Illustrated Parts List - IPL Update

T540XP II

Description of change

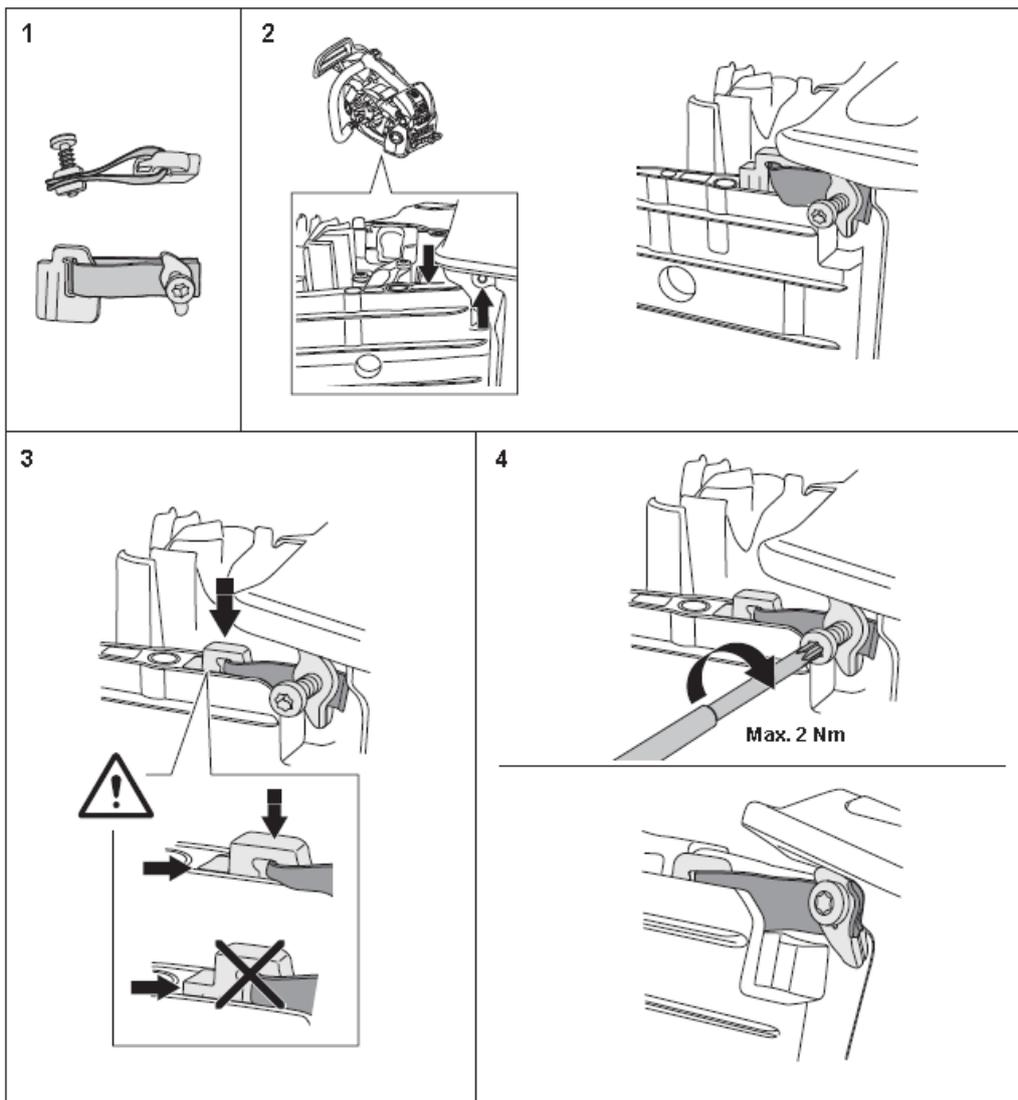
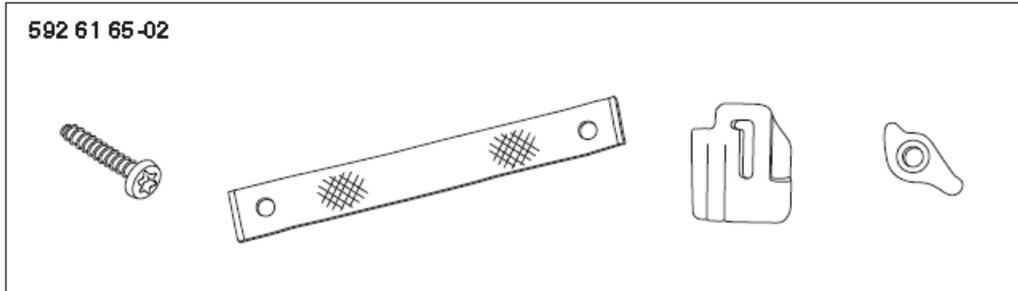
1. We have added a Deflection limiter, kit 592 61 65-02 between the Fuel tank and Cylinder cover.
Kit contains of: Instruction and limiter 592 61 65 cpl.
2. New kit 586 34 14-02 for Carburettor with instruction for AH.

This change is **not** fully exchangeable. From Fuel tank 522 59 02-05 fully exchangeable, for older fuel tanks the hole for the screw is to narrow.
